STAFF REPORT

PROPOSAL:
Bahr Vermeer & Haecker Architects, on behalf of Nebraska State Historical Society, requests a Certificate of Appropriateness for modifications to the NSHS Headquarters Building at 1500 R Street in the Capitol Environs District.

NEBRASKA STATE
HISTORICAL SOCIETY
HEADQUARTERS
RENOVATION

ARCHITECTURAL
RENDERINGS

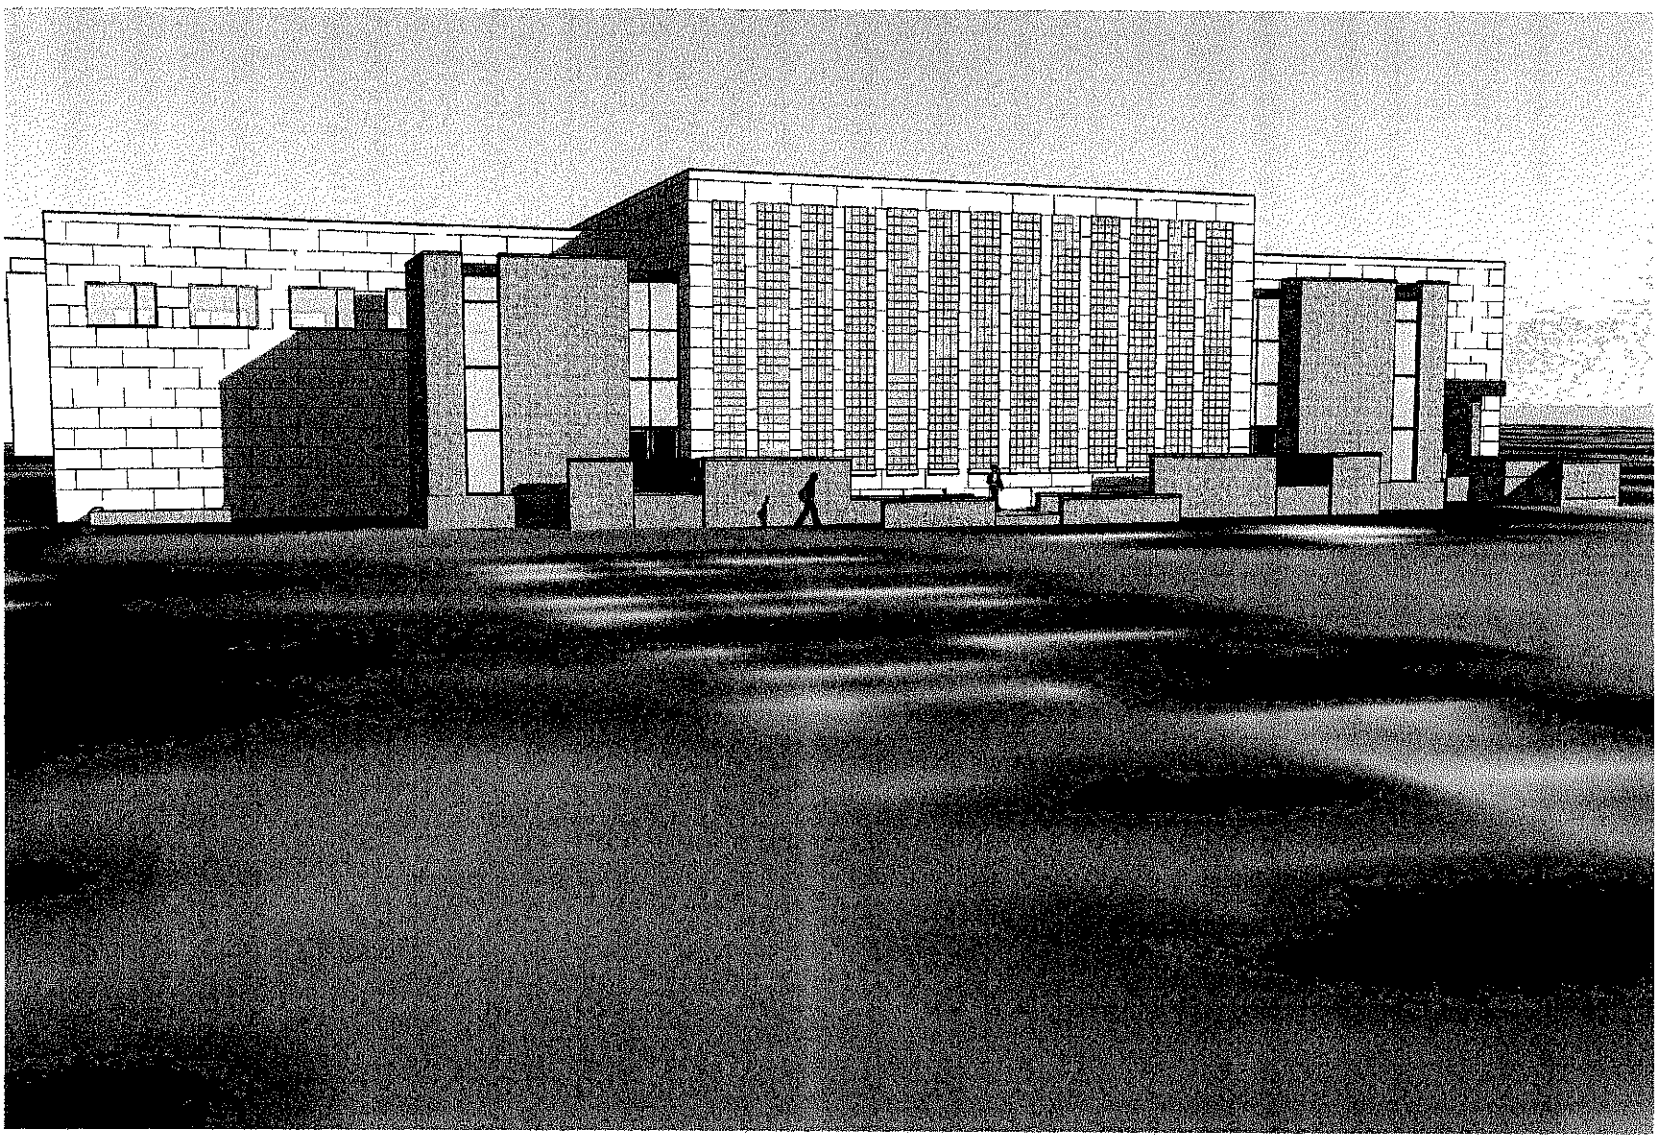
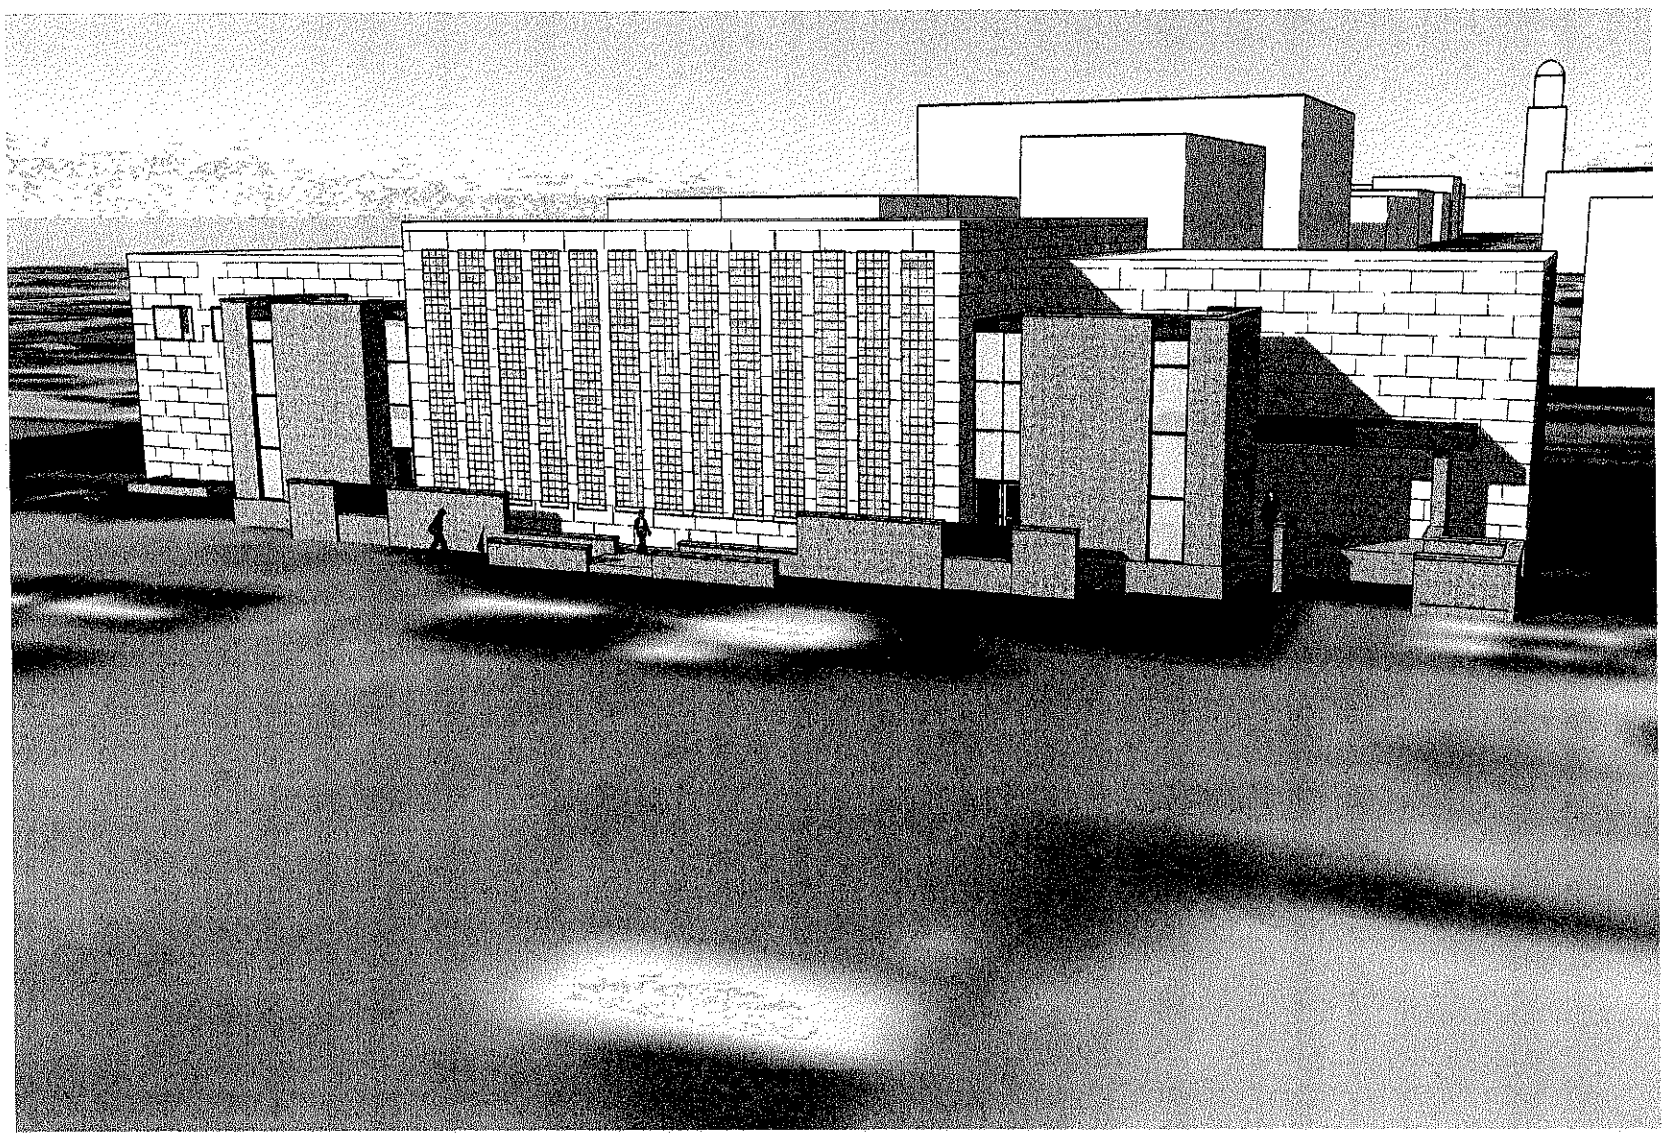
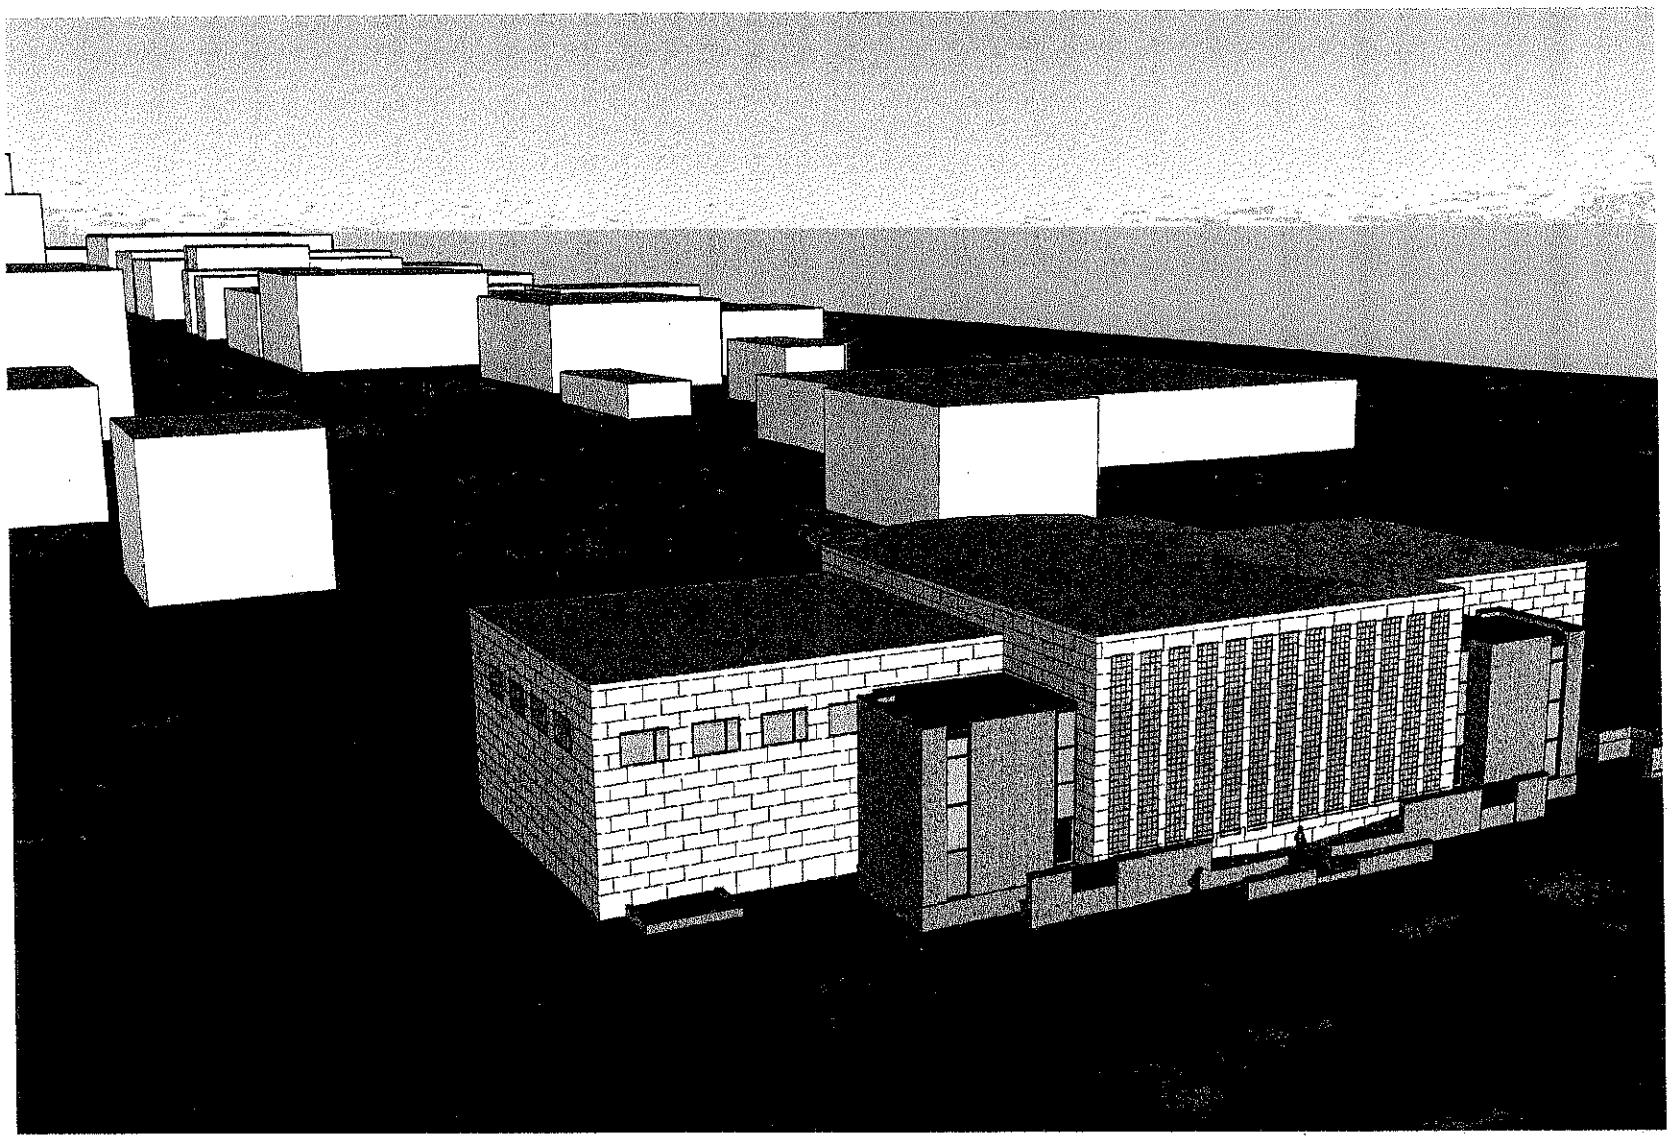
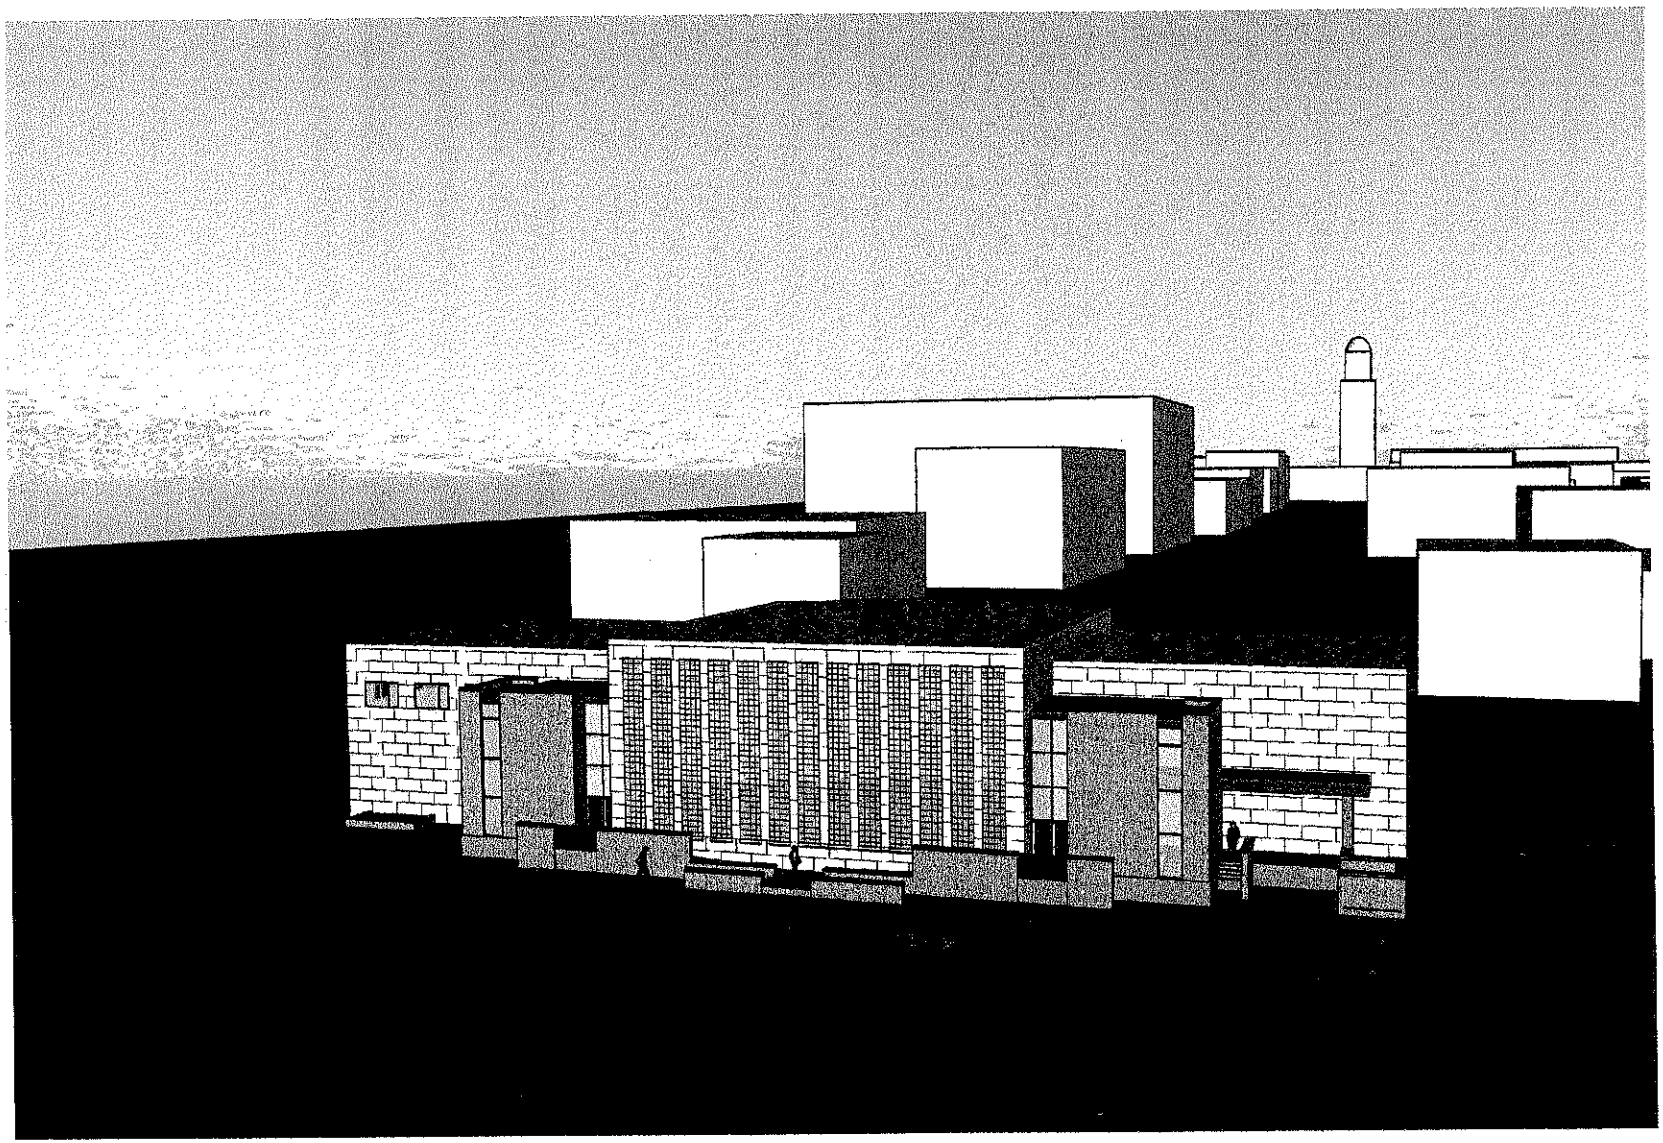
DISCUSSION:
The proposed renovation of the Historical Society HQ Building at 1500 R Street includes modifications on the north (rear) side, principally to provide stair towers. The work will not be visible from Centennial Mall and with the construction of the Multicultural Center by UNL at 15th & S Streets, will not be prominently visible from public streets.

The building site is near the north boundary of the Environs District and will have no visibility from Centennial Mall. In staff's opinion, the proposal easily meets the required standard of not intruding on the Capitol's setting and contributing to the overall quality of the District.

This handsome building is listed on the National Register of Historic Places. Even though the modification will be inconspicuous, it appears to have been very carefully considered by the Society and their architects, and in my opinion would meet the high standard set in the Environs District for new construction:

Recommended Finding: The proposed design meets the Capitol Environs Design Standards.

Recommended action: Approval of a Certificate of Appropriateness.
